Access Compliance Report Public Rights-of-Way (Curb Ramps)

Main Street: HARRISBURG_RD		Cross Street: SHAKESPEARE_DR		Location:	E
ADA ID: RPAT211202092848	Ramp Type:Type 1 - Perpendicular Diagonal Initial Pass/Fail: Fail		Overall Compliance: No	Severity Score:	15

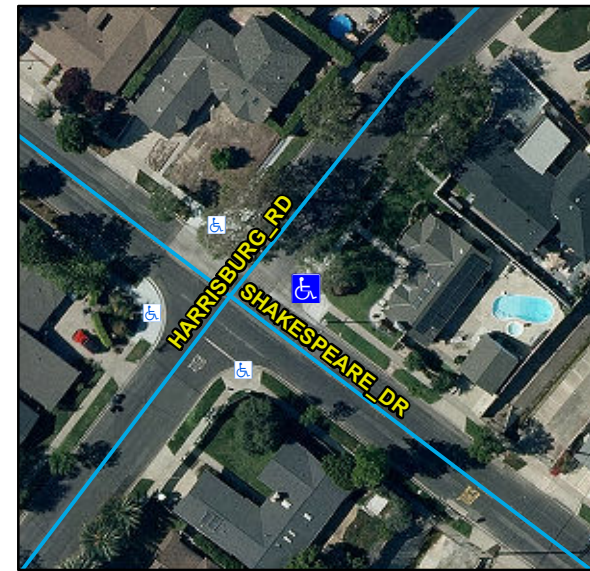
Compliance	Description	Data	Compliance	Description	Data
N/A	Ramp Length (in)	83	N/A	Flare Type LT	
Yes	Ramp Width (in)	48			N/A
No	Ramp Run Slope (%)	8.9	N/A	Flare Slope LT (%)	N/A
Yes	Ramp Cross Slope (%)	0.1	N/A	Flare Traversable LT	N/A
N/A	Landing Present	N/A	N/A	Flare Type RT	
N/A	Landing Length (in)	N/A			N/A
N/A	Landing Width (in)	N/A	N/A	Flare Slope RT (%)	N/A
N/A	Landing Run Slope (%)	N/A	N/A	Flare Traversable RT	N/A
N/A	Landing Cross Slope (%)	N/A	N/A	DWS Provided	N/A
N/A	Landing Movement Obstructed?	N/A	N/A	DWS Contrast	N/A
	Landing Movement Type	N/A	N/A	DWS Length (in)	N/A
N/A	Landing Shared	N/A	N/A	DWS Full Width	N/A
N/A	Clear Space	Yes	N/A	DWS Offset Left (in)	N/A
N/A	Clear Space To Crosswalk (in)	N/A	N/A	DWS Offset Right (in)	N/A
N/A	Marked Crosswalk 1	No	N/A	Marked Crosswalk 2	No
	Crossing 1 Direction	NE		Crossing 2 Direction	SE
	Marked Crosswalk 1 Width (in)	N/A		Marked Crosswalk 2 Width (in)	N/A

N/A	Ramp Inside Crosswalk 1	N/A	Yes	Ramp Inside Crosswalk 2	N/A
	Crossing 1 Slope (%)	1.2		Crossing 2 Slope (%)	3.2
	Crossing 1 Cross Slope (%)	2.5		Crossing 2 Cross Slope (%)	1
N/A	Gutter Ponding	N/A	N/A	Curb Slope	3.9
Yes	Gutter Lip Height (in)	0		Road Run Slope (%)	1.3
N/A	Gutter Run Slope (%)	N/A		Road Cross Slope (%)	2.2
N/A	Gutter Cross Slope (%)	N/A			
Yes	Overall Surface Condition: Acceptable		Yes	Perp Joint Present	Yes
	Cross Gutter Present?	Yes		Spandrel Present?	Yes
	Replace Cross Gutter?	No		Replace Spandrel?	No

Remove & Replace Curb Ramp With Two New Directional Ramps or Equivalent.

R304.2.2, STD 1115
